Figure 1. A Two Chip Cascade System

Figure 1. A Two Chip Cascade System

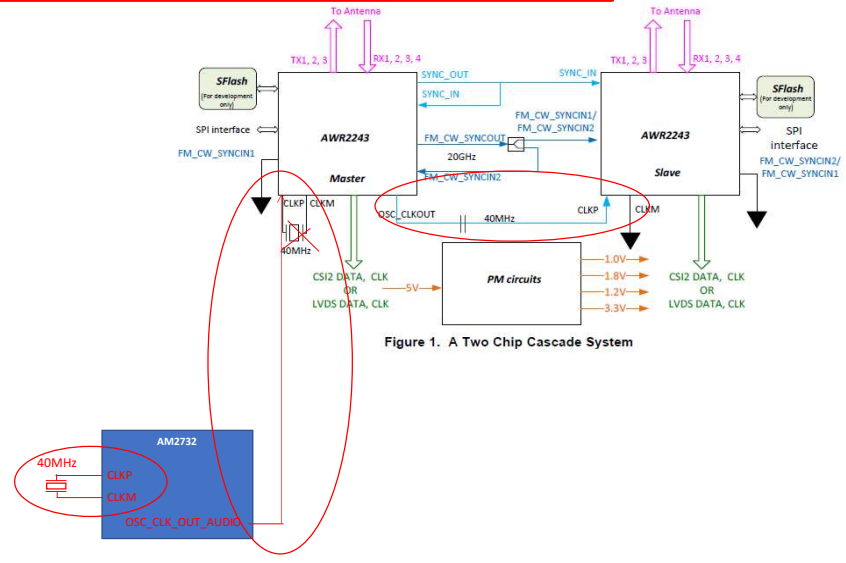
Question1.  
 - Is it necessary to construct a clock synchronization system including the processor (AM2732)?  
 - If we use "OSC\_CLKOUT" of the slave of the front end (AWR2243) to input the clock to the (AM2732) of the processor, the independent oscillator of the processor is not necessary. Is there a problem with this method?

Question3.  
 - Is the input to the processor (FE1\_REFCLK) correct for the connection shown in Figure 1?

Question2.  
 Which system would be better with the processor as the oscillation source, as shown in the figure below?
